PERMIT

SEWAGE DISPOSAL SYSTEM

ADDRESS 558 Obrecht Road, Sykesville, Maryland 21784 PHONE 795-5870

PROPERTY OWNER Jean Dewitt

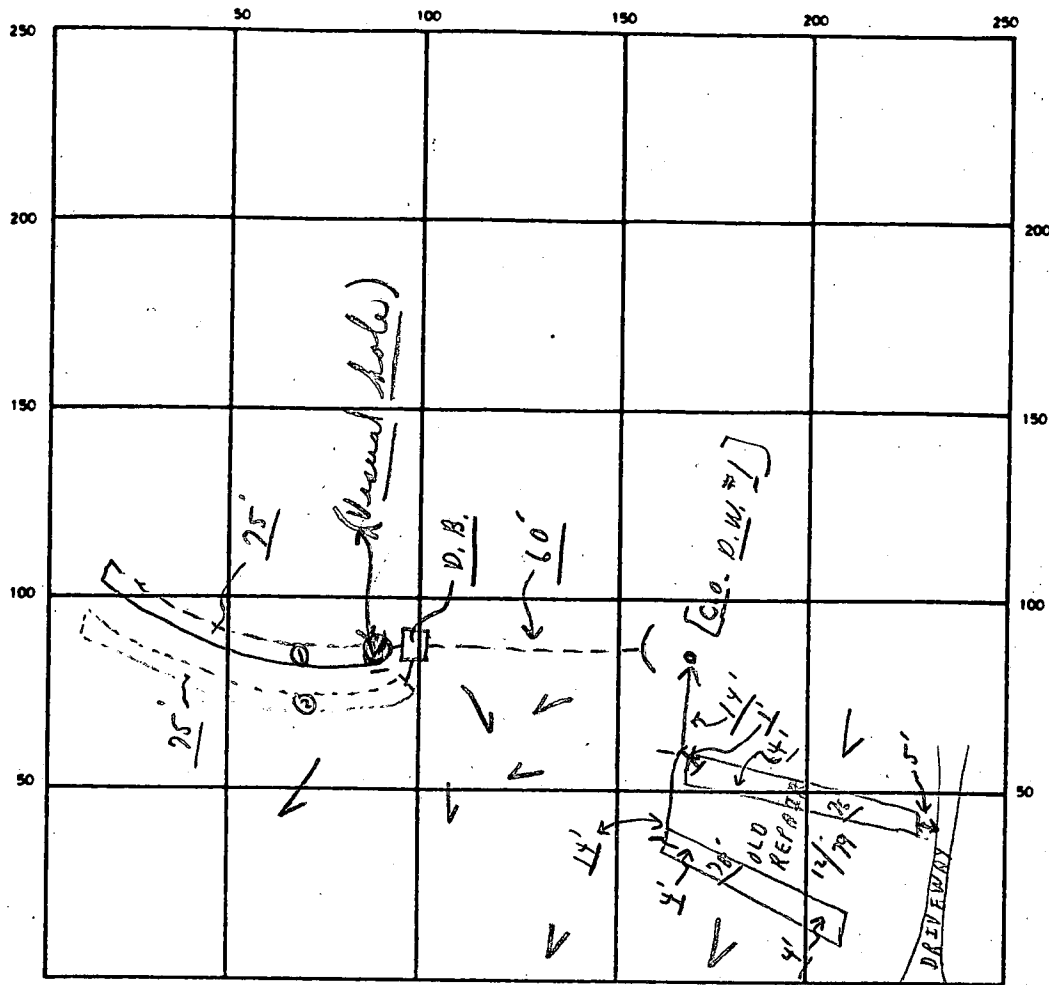
REMARKS (A.M.) 9/17/90 1 HOLE (VISUAL) 60' ± FROM EDGE OF EXISTING DRYWELL, 15' ± DEEP; (1'-4' CLAY, 4'-13 1/2' LOAM; 13 1/2' TO 15' WATER).
 GARDEN PLANTED OVERTOP OLD SHALLOW (REPAIR) PARTIAL HOLD FOR

(12:50 P.M.) 9/17/90 → T/C - CLOGGED LINE BETWEEN SEPTIC TANK & DRYWELL
 PER DALE FOGLE - TO REPLACE LINE ONLY - OK C.W. + C.B.D.
 THIS PERMIT CAN BE USED AT A LATER DATE, NO INSP. ON LINE/T/C CONVERSATIONS.
 HOLD THIS FOR A LATER DATE. C.W. + C.B.D.

[A.M. 9/17/90] (2) 3' wide trenches; 75' long for each, inlet
to be 2 1/2' to 3 1/2' below original grade and maximum depth 5' to 6'
below original grade. Location 60' out towards R 799
from old dry well edge (dry well to be used as
Dist. box) See back page drawing C.B.D. for
(Schedules 40 pipe to D. Box from Dry Well)
PLANS APPROVED BY C. Williams ← DATE 7/27/90

COVER NO WORK UNTIL INSPECTED AND APPROVED [P.M. 9/17/90] ↔ T/C to replace pipe only from S.T. to Dry Well

Dewitt Repair

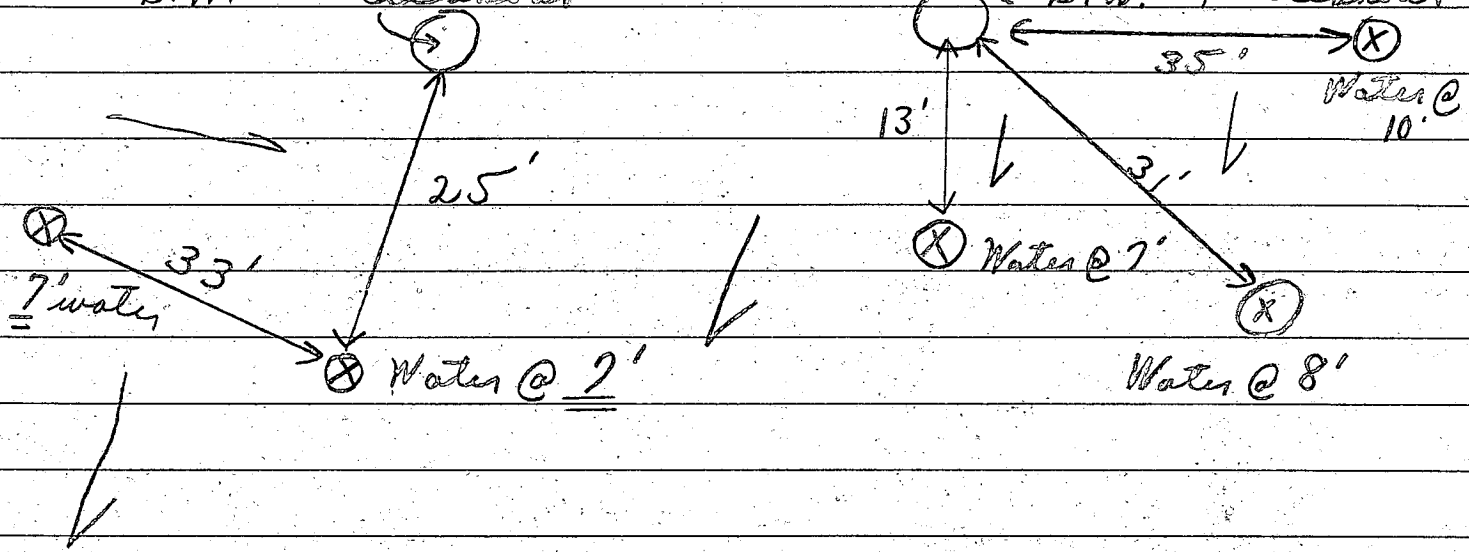
⊗ Water holes - water coming out sidewall of holes dug.

Note all holes clayish 1'-4"; Then mica loam or sandy loam to water table. Hold for discussion with engineer

(1) Dig at higher elevation near twin cleanouts. You put in a new tank there & drywell off it if soil is good.

(2) Discussion on 3' wide shallow 4' trenches for a trench bed. In area of old drywell. No deeper than 4' below grade D.W. M + C.B.D.
